25 June 2019

Our ref: 773-CHCGE231429

Liquefaction hazard assessment and Technical Category advice for the proposed subdivision at 308 – 322 Halswell Junction Road, Halswell

Figure 1: Overlay showing all CPTs predicted settlement verse depth (SLS2)

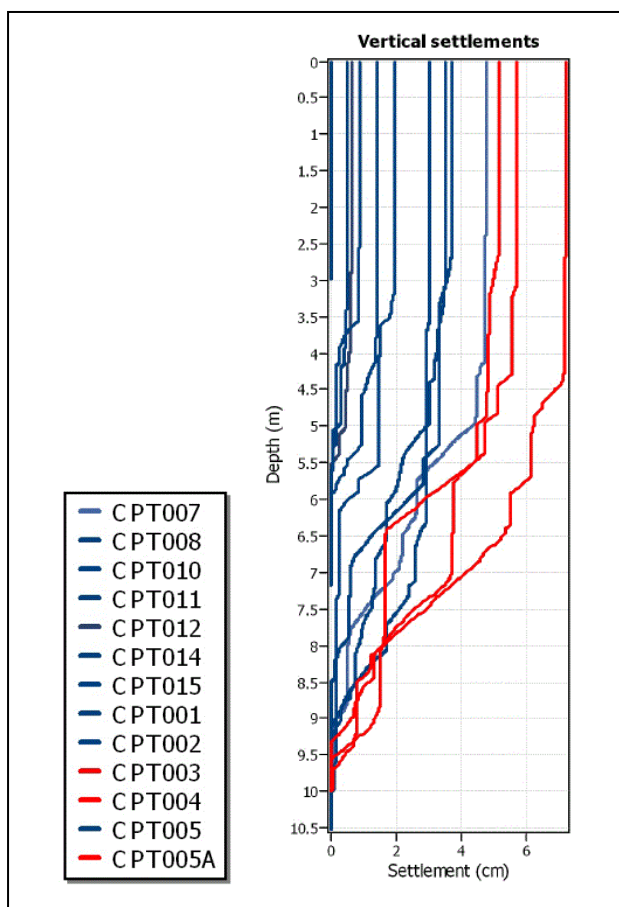
Given the depth to liquefiable material Coffey consider that the predicted liquefaction induced settlement values which indicate TC3-like settlements for the SLS2 case in CPT03, CPT04 and CPT05A are not representative of the likely ground performance in a future earthquake event. This is further shown in Figure 1 which shows an overlay of the predicted vertical settlement verses depth for the SLS2 case. In this figure the red lines represents the TC3-like CPTs and the dark blue indicates the TC2-like CPTs. The figure clearly shows that the difference in predicted settlement between the CPT plots which has resulted in different TC classifications is concentrated below 4.5 mbgl. This provides a significant 4.5m thick “crust” of predominantly non-liquefiable material which is likely to reduce the surface manifestation of liquefaction across the entire site.

For this reason Coffey have completed an additional analysis which calculates the LSN values for each of the cases described above. This analysis is included in Section 4.2.2 of this report.
